## GROUP 51

# EXTERIOR

### OUTLINE OF CHANGES

## FRONT BUMPER

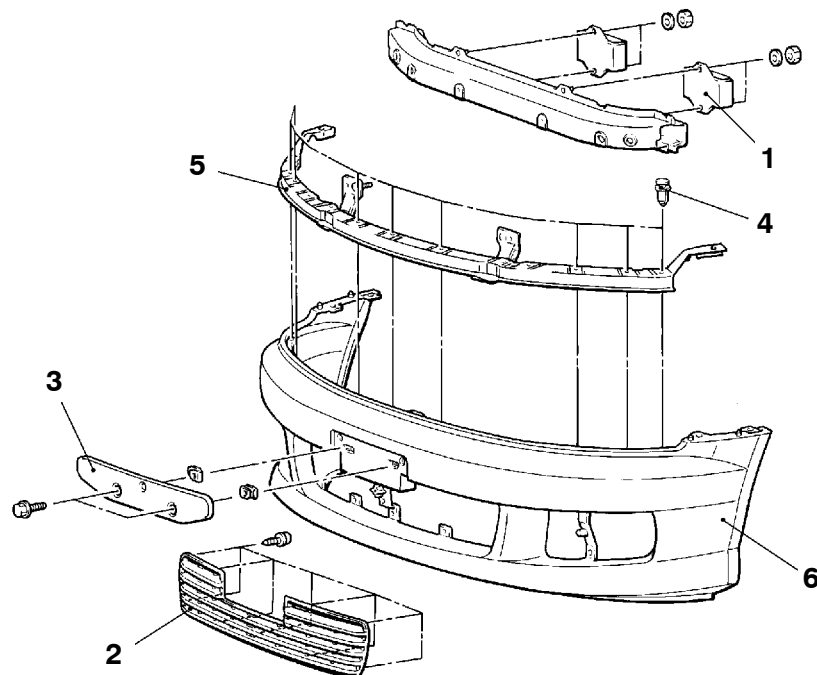
- Service procedures have been changed due to the modification in the front bumper.
- Service procedures have been changed as “Mitsubishi” mark is changed into Three Diamond mark.
- GHI mark is added to correspond to the addition of the GDI engine models.

1. Fog lamp bezel
2. Fog lamp
3. Front bumper assembly
4. Front bumper reinforcement assembly
